Zero Effort DTS Control Replacement

DTS Zero Effort Controls with throttle lever detent.

- a - Previous style
- b - Current style

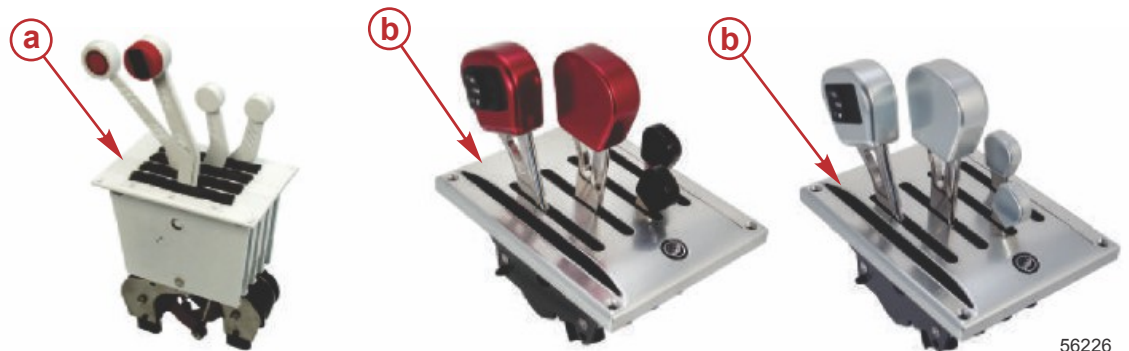
With a few exceptions, Mercury Racing no longer manufactures complete assemblies of the previous model DTS Zero Effort control. Previous models are identified by their color (Black or White), with the throttle lever having a series of detent positions. Individual service replacement parts are available through the electronic parts catalog. Refer to the control listing to see which controls are still active for manufacture.

The current control cover is smaller than the previous control cover. If you choose to replace the previous control with a current control; the previous control opening will have to be reworked to cover the exposed area of the opening. There is nothing available from Mercury to rework the current control opening.

Orders for the previous controls will be filled until the inventories are depleted, then they will no longer be available. To order a current model, locate the style you want to replace and order the **New Color** or **New Clear** part number directly to the right of the old part number.
